Docket Item # 1
BAR CASE # 2011-0032

BAR Meeting
March 2, 2011

ISSUE: Alterations
APPLICANT: 1555 King St Court LLC
LOCATION: 1555 King Street
ZONE: KR / King Street Urban Retail Zone

Figure 3. Perspective of proposed awning design.

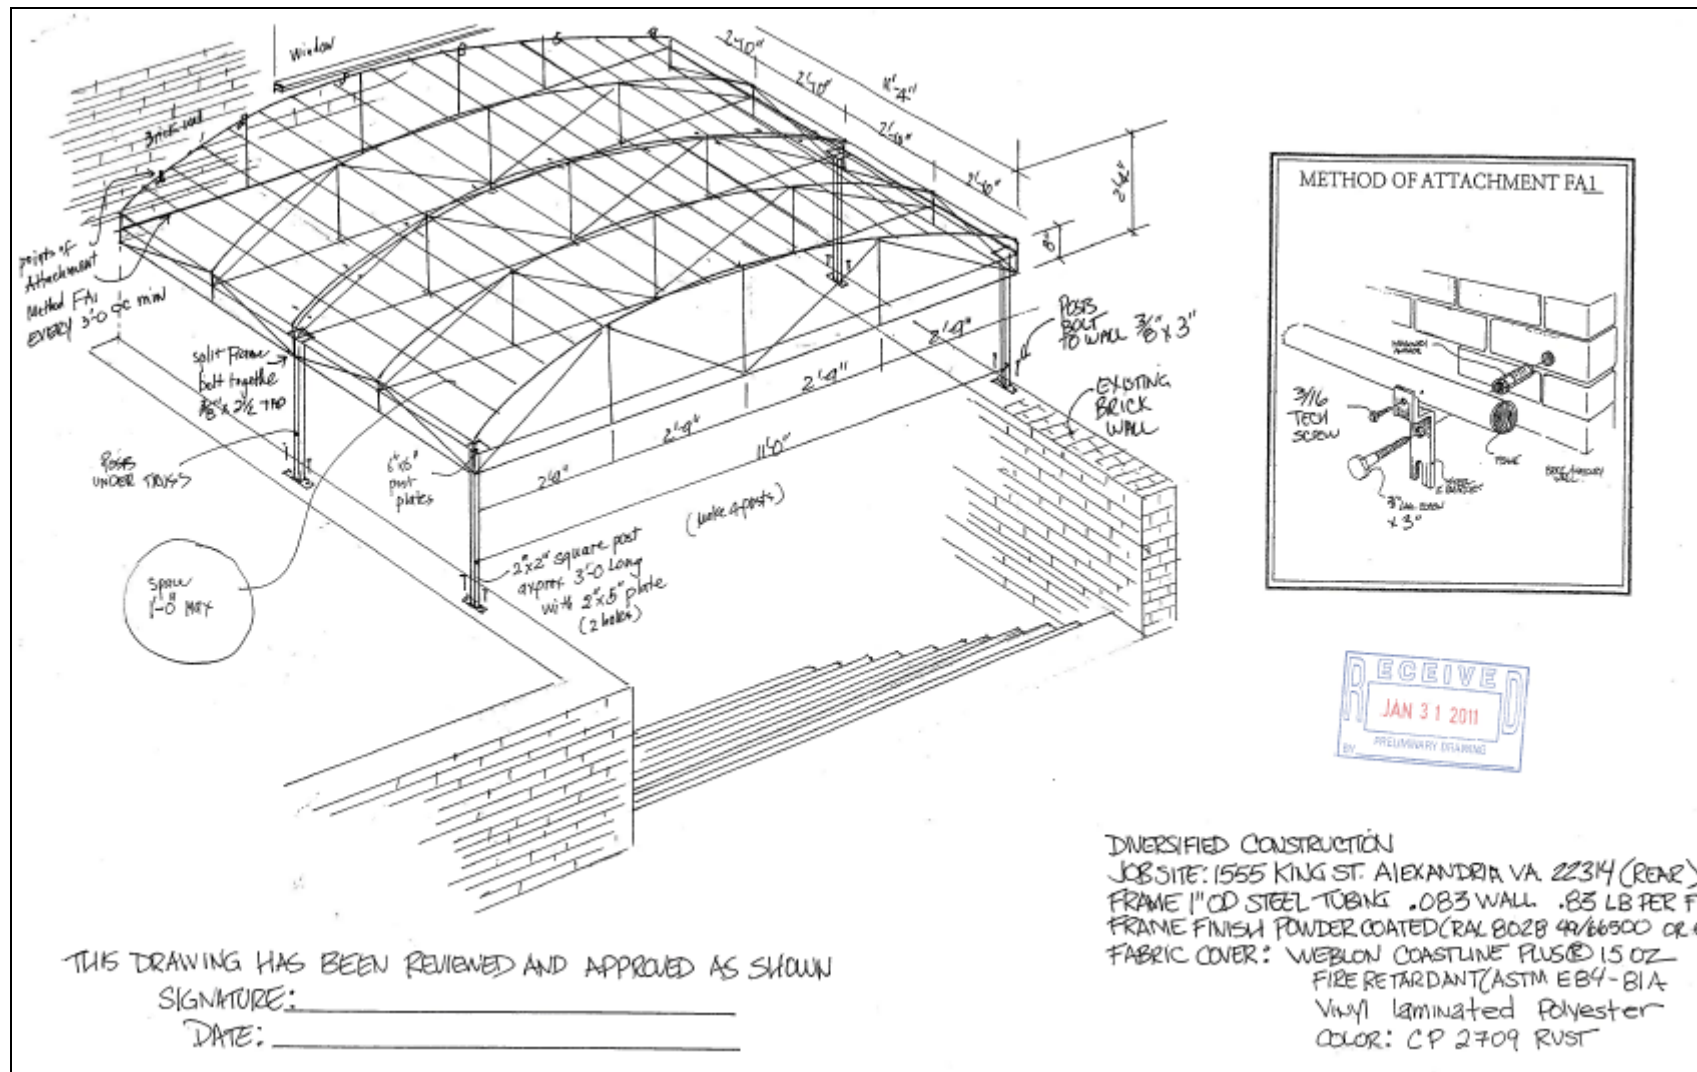
Staff has no objection to the proposed awning. The *Design Guidelines* state that "awnings should be appropriate and sympathetic to the historic style of the building to which they are attached" and "should not overwhelm or obscure the architecture." In addition, the *Guidelines* state that "awnings should be made of a canvas type fabric" and "the color should be appropriate to the building." Although the drawings state that the awning material is a vinyl polyester, the proposed sample swatch is for a canvas-like material typically approved by the Board for awnings. While a vinyl material is not compliant with the *Design Guidelines*, a canvas or similar fabric material is appropriate. The applicant has indicated that the material stated on the drawing is incorrect. Therefore, Staff will require that the drawings be revised to indicate an appropriate material is used.

Staff finds that the proposed awning meets the criteria set forth in the *Design Guidelines* and finds the awning to be appropriate to this modern building. The form of the awning reflects the segmental arch of the building entrance. Although the awning is large in size, the building to which it will be attached is a large commercial building and will be able to prevent the accumulation of snow and ice on the steps to the rear entrance. Furthermore, the awning will be minimally visible from the public right-of-way and is designed in a way that it can be easily removed at a future time without damage to the existing building. Staff recommends that the

wall fasteners be attached through the mortar joints rather than through the brick, to prevent damage to the brick.

1. That the awning fasteners attached to the brick wall be installed through the mortar joints rather than through the brick; and
2. That the awning material be a canvas type material, to be approved by Staff prior to application for a building permit.

Figure 4. Front and side elevations of proposed awning.

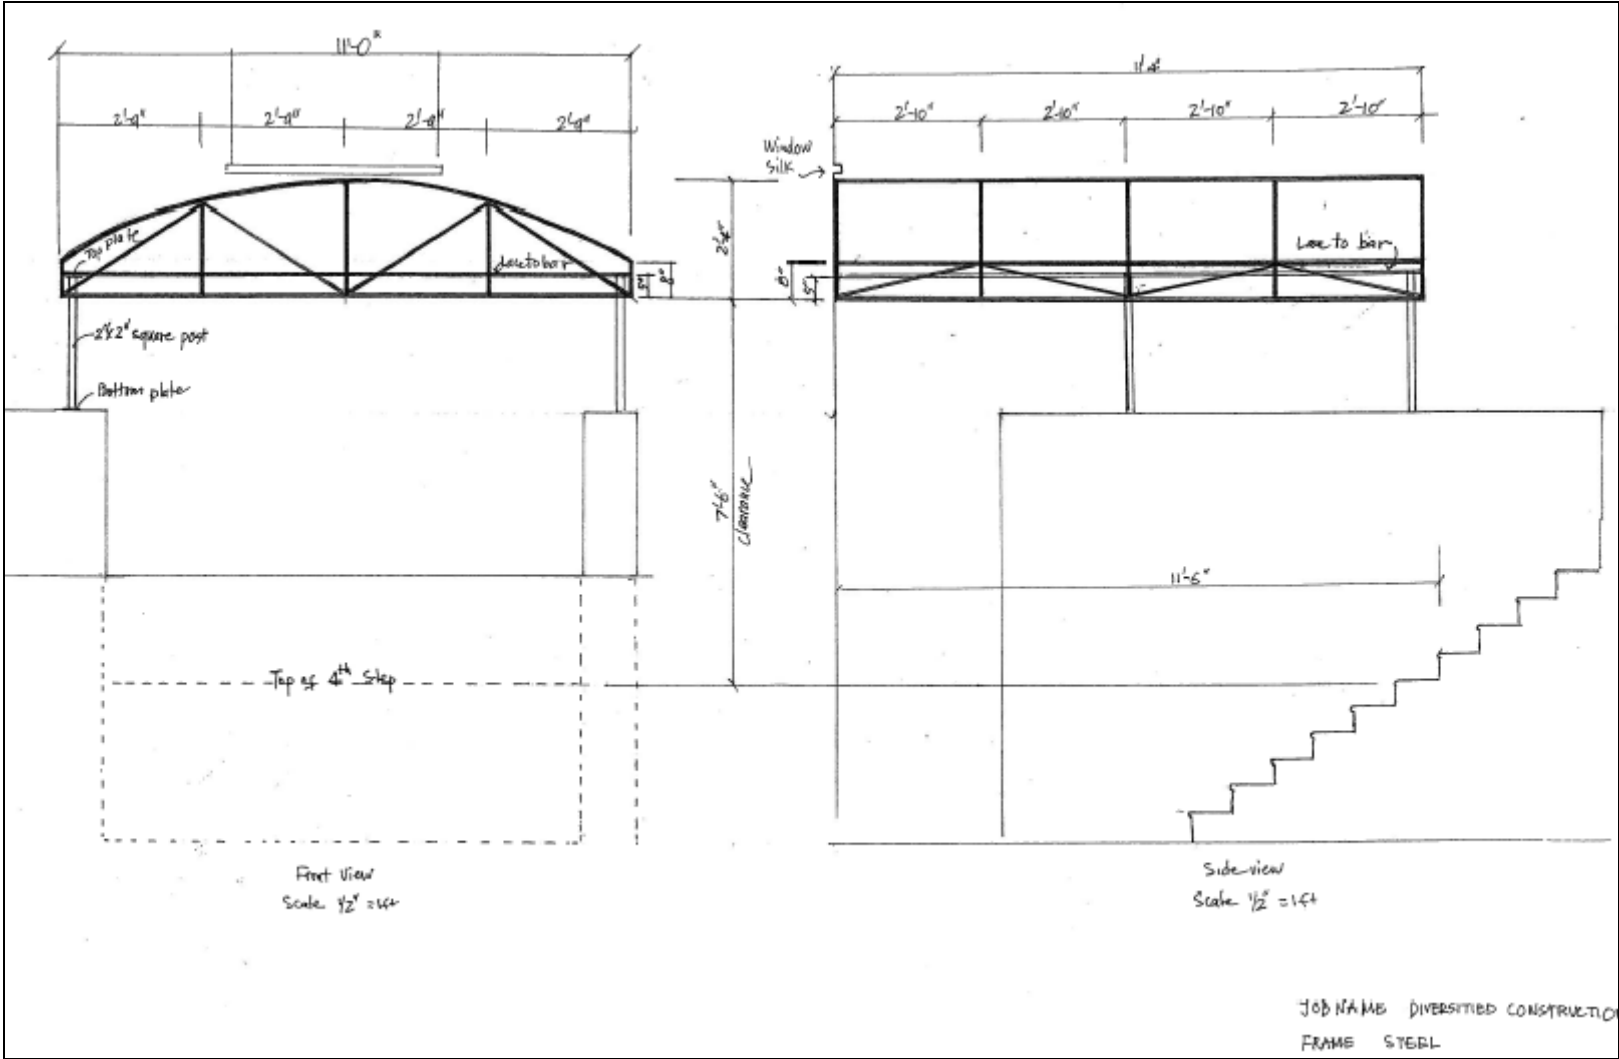
- C-1 A building permit is required to be issued prior to the installation of the new awning.
- C-2 Canopies must comply with USBC 3202.3.1 for support and clearance from the sidewalk, and the applicable sections of USBC's Chapter 11. Structural designs of fabric covered canopies must comply with USBC 3105.3. The horizontal portions of the framework must not be less than 8 feet nor more than 12 feet above the sidewalk and the clearance between the covering or valance and the sidewalk must not be less than 7 feet.

- C-3 Canopies must comply with USBC 3105.1 and the applicable sections of USBC: Chapter 16. Structural designs of fabric covered canapés must comply with USBC 3105.3.

- C-4 Awnings must comply with all applicable requirements of USBC 3105.3 and 3202.3.1 Retractable and fixed awnings must have a minimum 7 foot clearance form a sidewalk to the lowest part of the framework or any fixed portion of any retractable awning is required. Retractable awnings must be securely fastened to the building and can not extend closer than 24 inches in from the curb line (USBC 3202.3.1).
